## MEASURE REPORT

MODEL	TDR240/250, TZR250	FILE	
SUBJECT	PISTON MELTING AT CROWN	<a href="http://www.legends-yamaha-enduros.com">www.legends-yamaha-enduros.com</a>

MODEL	TZR250 '87, '88	<a href="http://www.legends-yamaha-enduros.com">www.legends-yamaha-enduros.com</a>	FILE	
SUBJECT	PISTON SEIZURE

MODEL	TZR250 '87, '88	FILE	
SUBJECT	PISTON RING BREAKAGE <a href="http://www.legends-yamaha-enduros.com">www.legends-yamaha-enduros.com</a>

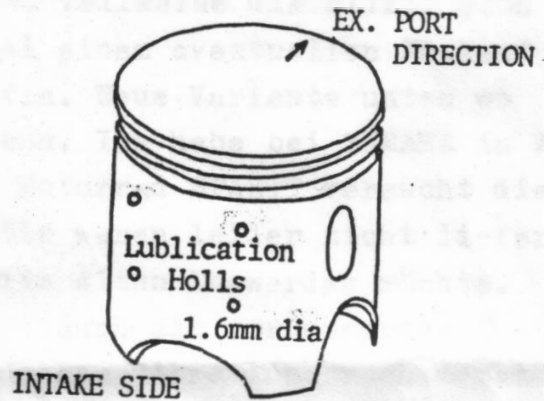
Market report indicate knocking engine noise and piston seizure.

At the early break-in of an units, some units may be experienced scuffing between piston and cylinder wall insufficient lubrication. Then scuffing caused to piston seizure.

To prevent scuffing at early break-in, we are going to change the piston design as simlure with 2YK type (TDR250) as a next model. The 2YK type piston has four location of lubrication holls at intake side as shoun in the left. These holls will provide greater lubrication effect between piston and cylinder wall comparison with present ones.

If you encounter a smilure problem, please recommend your dealer to use following part instead of STD ones. Recommended piston is as same as TDR250 model's one.

Alte Variante

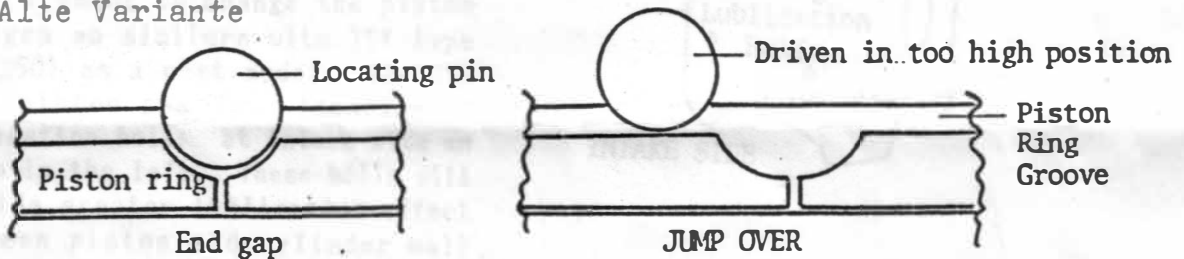
Market report indicates that the a piston ring is broken catching with cylinder port.

The piston ring located pin may be experienced driving into piston ring groove with insufficient dimension accuracy in some units ( drivig upward comparison with specified location ) . And also locating pin can be worn. These matter may cause that piston ring end gap can jump over the locating pin and then end gap will catch with cylinder ports. See below.
